SUBJECT: Forwards responses to items from cont audit on 810819-20.

SUSQUEHANNA STEAM ELECTRIC STATION
NRC SQRT AUDIT OPEN ACTION ITEMS
ER 100450 FILE 148-01
PLA-988

Attached are the responses to the following items from the SQRT audit of August 19-20, 1981:

MANUFACTURERS OF SAFETY-RELIEF VALVES

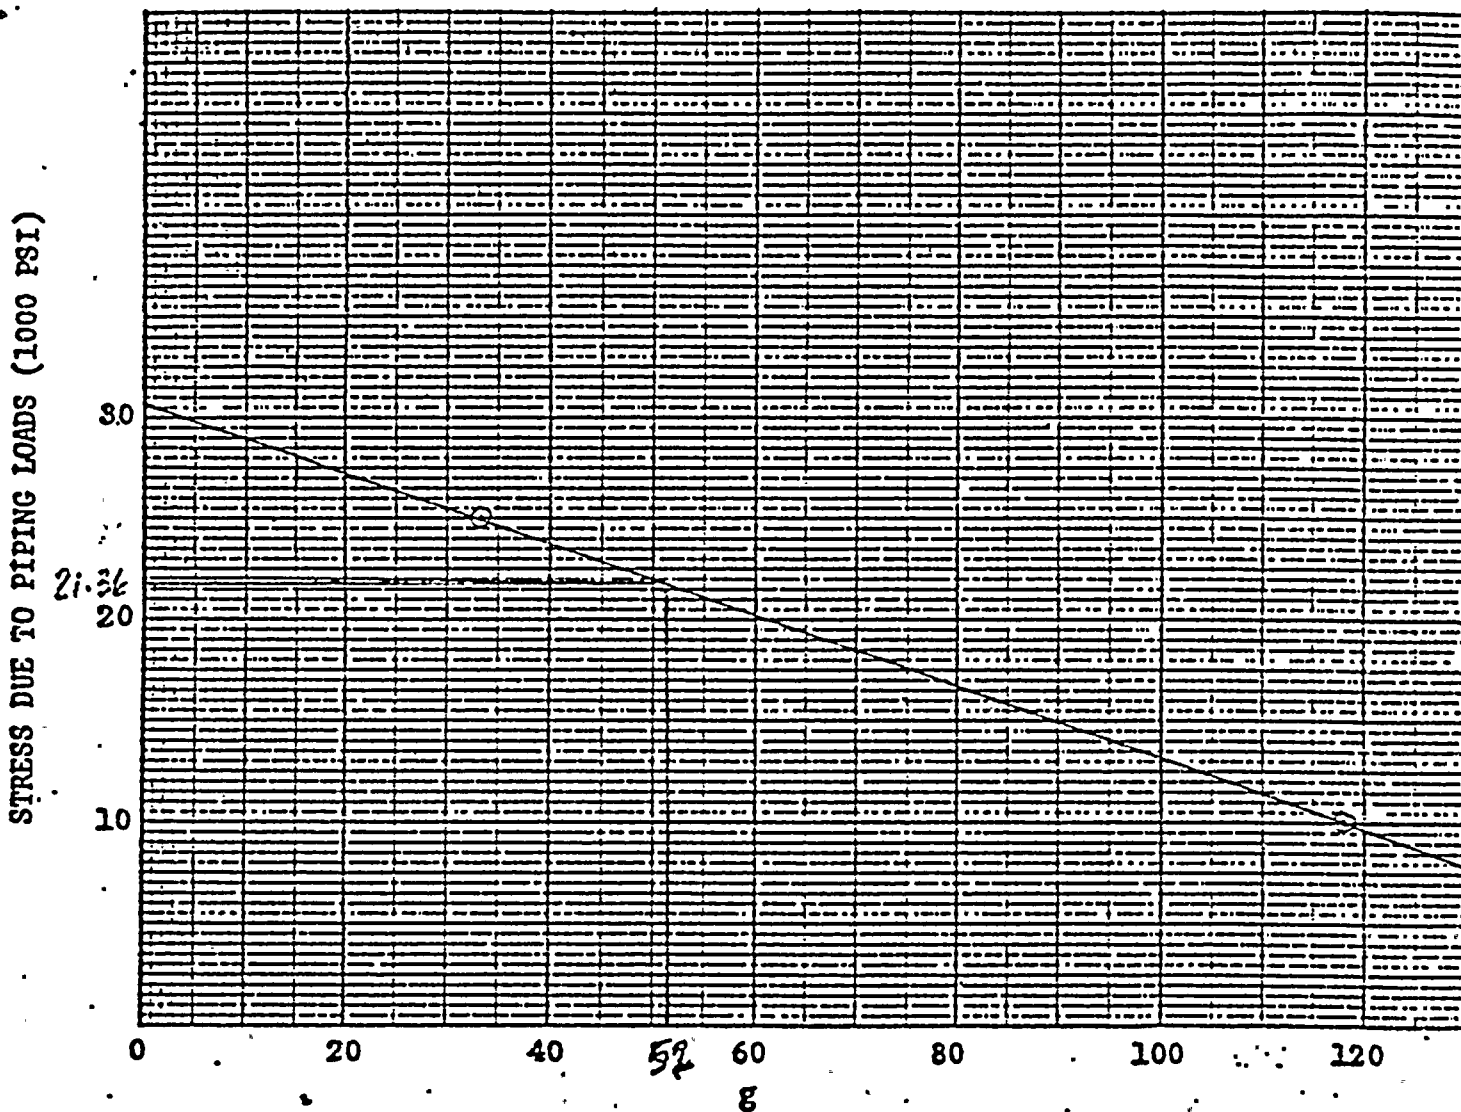
For the valves audited, provide confirmation that the acceleration 'g' values used in the qualification are correspondingly equal to or less than those obtained from the final as-built piping analysis (12/31/81).

The following sheets 2 through 4 summarizes the desired confirmation in a tabular form.

Figure - 1 : SCHEMATIC MODEL OF
DOWNCOMER WITH VACUUM
RELIEF VALVES

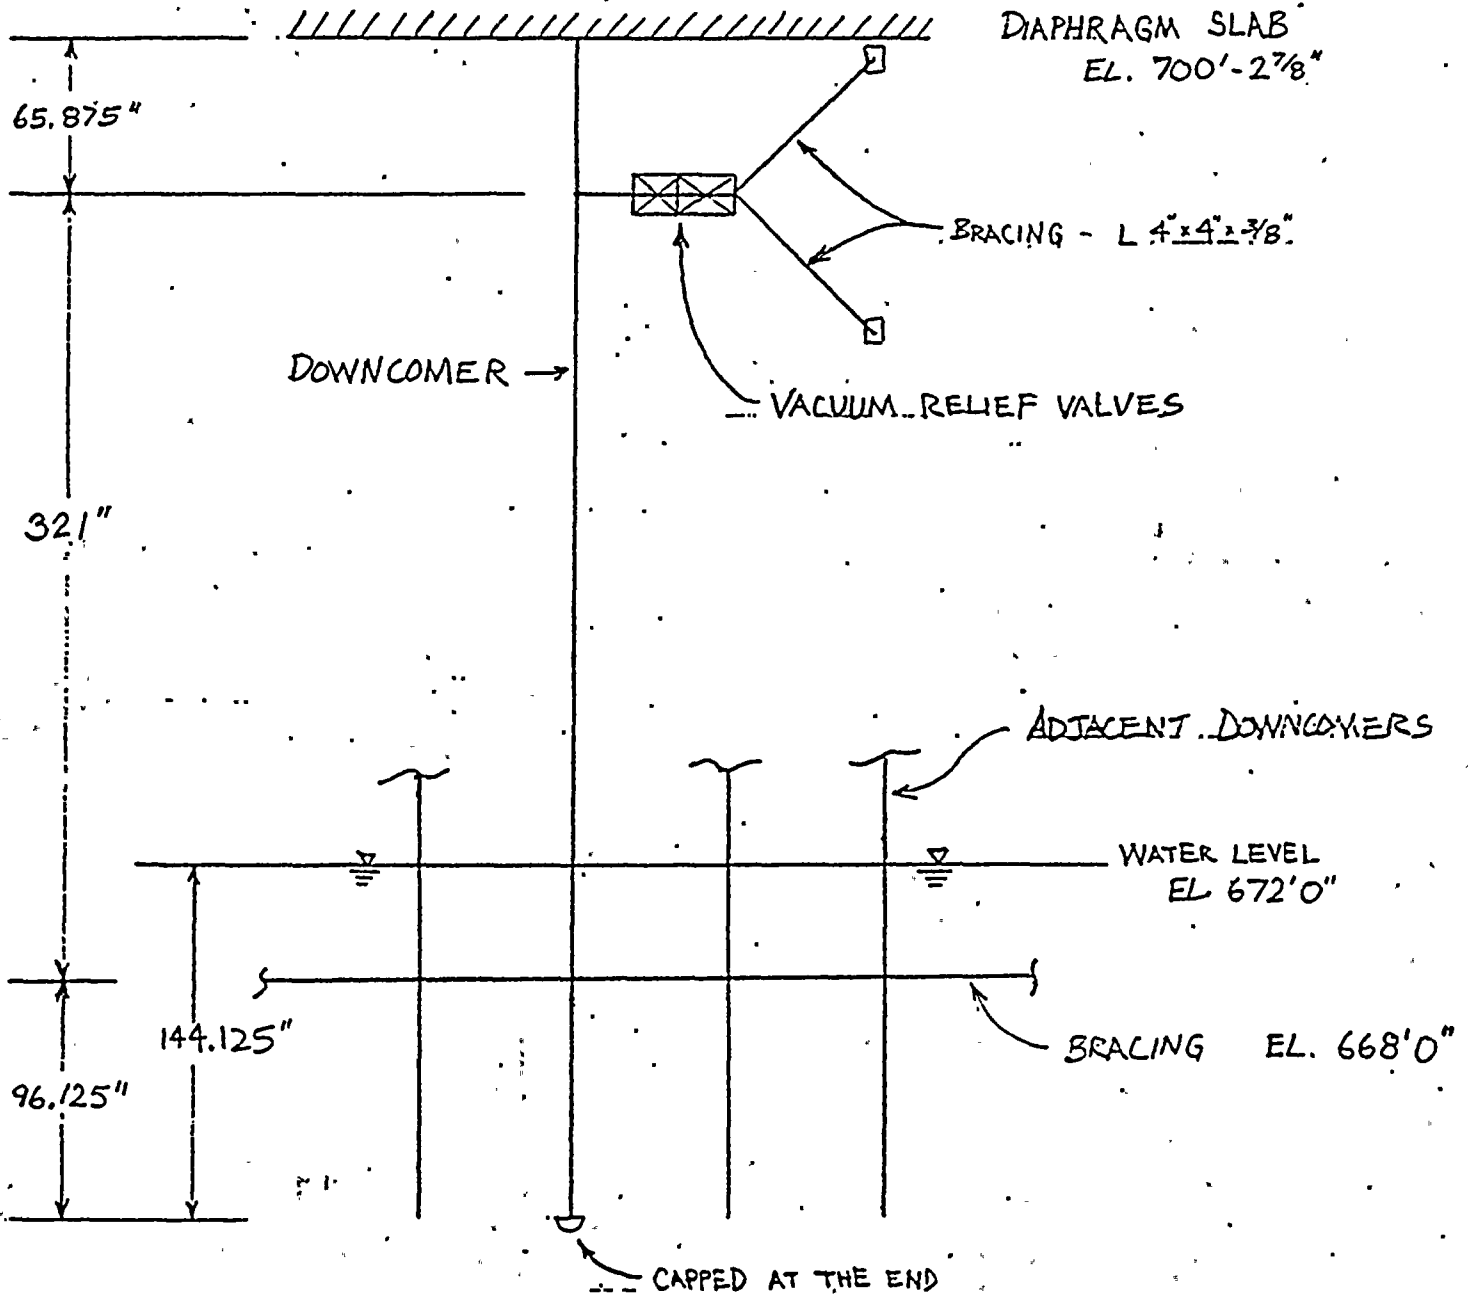
For Containment Vacuum Relief Valve (M-149) provide clarification for the consideration of the loads at the free end of the downcomer during qualification (12/31/81).

There are five pairs of vacuum relief valves in each unit. The valves are in series and bolted to T-flanges of the downcomer at one end and supported by a pair of diagonal bracing angles (4" x 4" x 3/8") on the outboard end. The model for the analysis of the valves includes the details of the valve components, the downcomer, the downcomer bracing system and the bracing angles as shown in the attached Figure 1.

In addition to the dead load and the pressure load (vacuum operating set pressure of 0.5 psi; positive design pressure of 53 psi), the following dynamic loads have been considered in qualifying the valve:

The present configuration is such that the downcomer carrying the vacuum relief valves are capped at bottom ends. Hence, the direct tip load due to chugging is eliminated for these vents. However, the effect of the tip loads from the adjacent downcomers as transmitted through the bracing has been considered for a multiple vent discharge. This load consists of a 30 kip impulse applied as a half sine wave with a duration of 3 milliseconds. A multiple vent discharge factor of 0.25 is taken into account.

- (i) the responses for the SRV inertia load and the SRV submerged structure load are added absolutely.
- (ii) the responses for LOCA inertia load, LOCA submerged structure load and the chugging tip load are added absolutely.
- (iii) the responses from the above (i & ii) SRV and LOCA and the responses from seismic loads are added by SRSS method.
- (iv) the total dynamic responses from (iii) are then added to the results of dead load and the pressure loads are added absolutely to obtain the final stresses and displacements.

The analysis of the valve show that there are adequate margins of safety in all the valve components and hence, it is concluded that the valve is satisfactorily qualified for hydrodynamic loads.
